**INDEPENDENT ASSESSMENT
OF
BASEMENT IMPACT ASSESSMENT
FOR PLANNING APPLICATION 2014/1495/P**

**FOR
9-11 MANSFIELD ROAD
LONDON
NW3 2JD**

**Project No. P2955
November 2014**

**Document Reference IH/P2955/Issue 2.0
UPDATED TO REFLECT REVISED SUBMISSION**

4.1 Proposed Construction Methodology

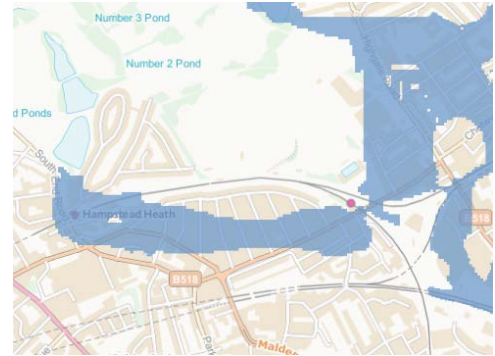
- 4.1.01 The proposed construction methodology has been set out on the Martin Redstone drawings. These have been reviewed only in respect of their meeting the principles of DP27. We have not considered whether they can or will be accepted by adjoining properties in respect of the Party Wall act.

- 4.1.02 An appropriate methodology appears to have been selected, provided the assumption is valid that the rate of ground water ingress will be low and can be pumped from the excavation.

- 4.1.03 Δ Given the relatively limited data available for the site on ground water levels and flows, consideration should also be given for condition where water inflows to the investigation are more significant. The revised BIA notes in section 6 (Scoping) that trial excavations will be carried out prior to construction to enable such an assessment to be made.

- 4.1.04 Δ Within section 6 (Scoping) of the report, a possible mitigation measure is given as 'dewatering'. It is assumed that the requirement for mitigation will be evaluated following the trial excavations. If dewatering is the proposed solution then the potential impact on ground stability within the adjoining properties would also need to be assessed at that time.

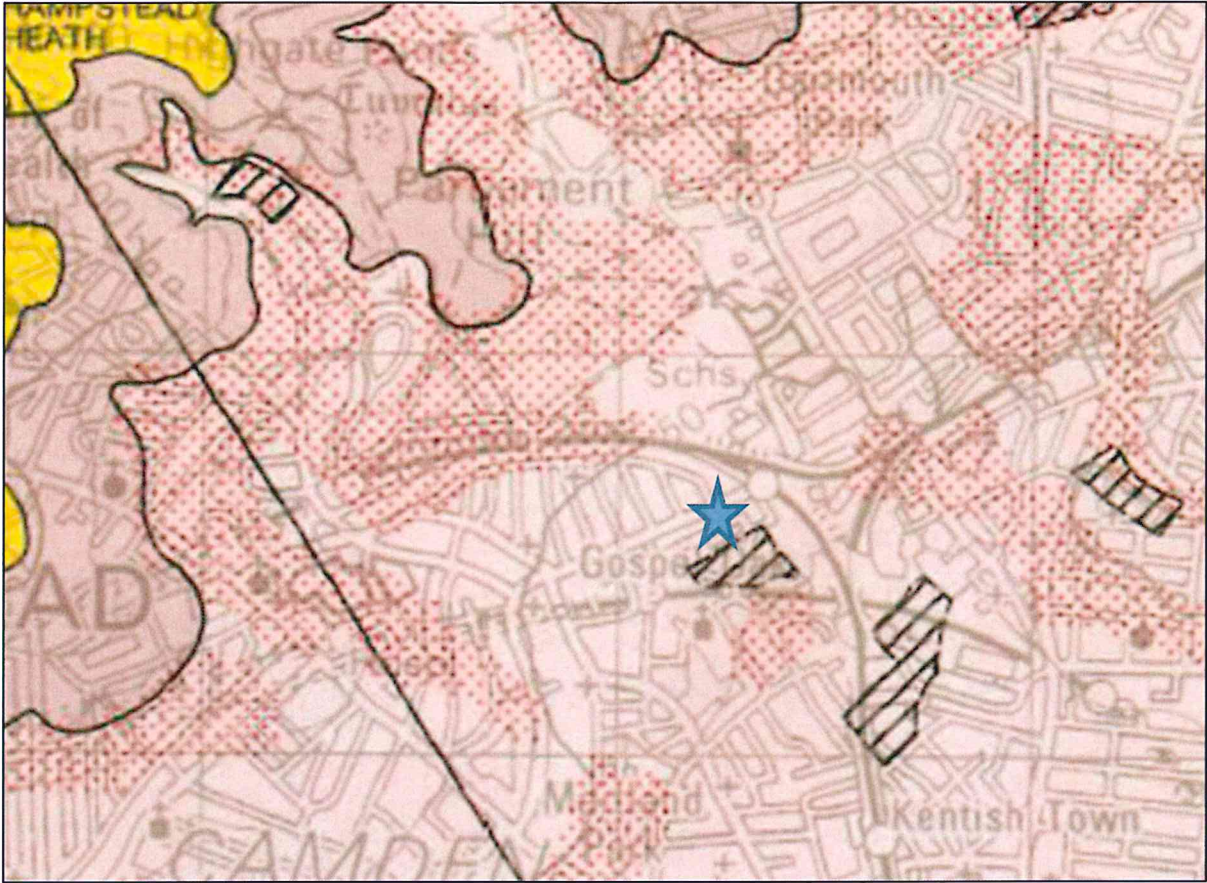
The ground investigation has indicated a covering of superficial soil, extending to a depth of 2.6 m, which is underlain by London Clay. The Ramboll report and the SAS report describe these shallow soils as Brickearth, which we do not consider to be correct, mainly in view of their geological and geomorphological setting. The most recent version of the British Geological Survey map of North London (sheet 256) indicates areas close to the site where there is a propensity for Head Deposits over the London Clay, as shown on the map extract below. We therefore consider that these shallow soils are probably Head Deposits.

Ramboll describe the "Brickearth" as permeable, which we do not consider to be accurate. Based on the soil description and the accompanying laboratory data, this upper layer of soil includes varying amounts of gravel and has a variable moisture content; it will have a higher permeability than the London Clay, but is not considered to be "permeable" and will let water through relatively slowly due to the high proportion of clay. The higher permeability should however be considered in the design of the basement; this is not a significant issue, but the contractor should have an expectation that there may be inflows into the excavation at a rate that is higher than through the London Clay.
